AMENDMENT OF SOLICITATION/MODIFICATION OF CONTRACT				1. CONTRACT ID CODE	PAGE 1 OF 2 PAGES
2. AMENDMENT/MODIFICATION NO. AMENDMENT NO. 0002		3. EFFECTIVE DATE 9/19/12	4. REQUISITION/PURCHASE REQ. NO.	5. PROJECT NO. (If applicable) 12-0091	
6. ISSUED BY CODE		CODE mks	7. ADMINISTERED BY (If other than Item 6) CODE See Item 6		
6. ISSUED BY Officer in Charge of Construction MCI-East 1005 Michael Road Camp Lejeune, NC 28547-2521					
8. NAME AND ADDRESS OF CONTRACTOR (No., street, county, State and ZIP Code)				(X)	9A. AMENDMENT OF SOLICITATION NO. N40085-12-R-0091
				X	9B. DATED (SEE ITEM 11) 9/13/12
					10A. MODIFICATION OF CONTRACT/ORDER NO.
					10B. DATED (SEE ITEM 11)
CODE		FACILITY CODE

12-0091, HVAC/DHW Energy Improvements Various Facilities Hadnot Point

<p>Wiley Wilson Constant Progress</p>		<p>120091 HVAC/DHW ENERGY IMPROVEMENTS VARIOUS FACILITIES HADNOT POINT</p>		<p>SKM-1</p>
		<p>MODIFIED EQUIPMENT PAD DETAIL - RESPONSE TO RFI #1</p>		
<p>6606 West Broad St, Suite 500 Richmond, Virginia 23230-1717</p>	<p>212098</p>	<p>DRW: SWL</p>	<p>CHK: IM</p>	<p>ALL SHEETS</p>

EXTERIOR EQUIPMENT PAD DETAIL

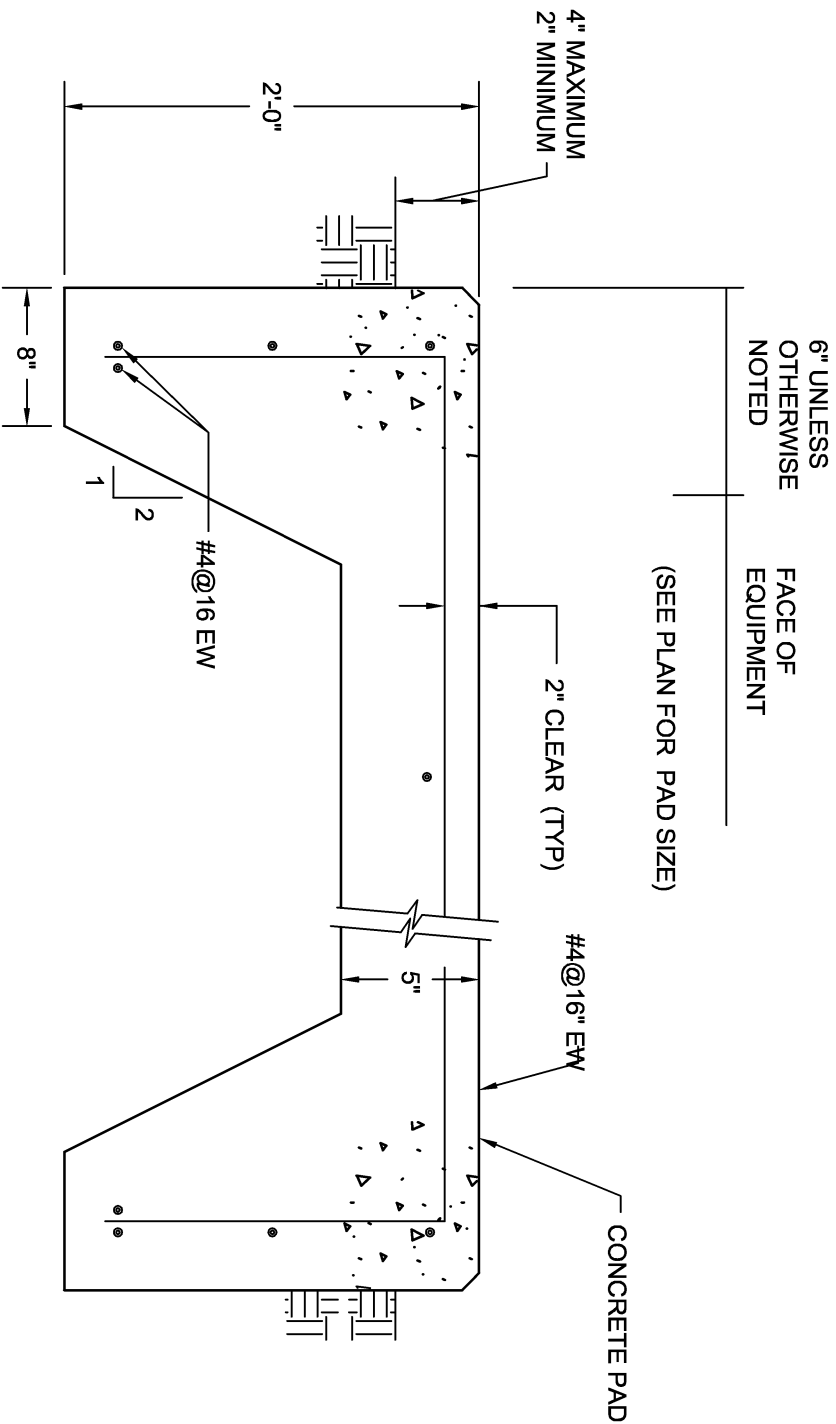
1. Q: The exterior equipment pad for each of the buildings shows a 8" thick concrete pad with 2' deep turndowns on the ends. This is very costly for 4 and 5 ton condensing units. We typically install 4" condensing unit pads for 4 and 5 ton condensing units. Would that be acceptable on this job?

1. A: Attached is a modified equipment pad detail in response to this question.
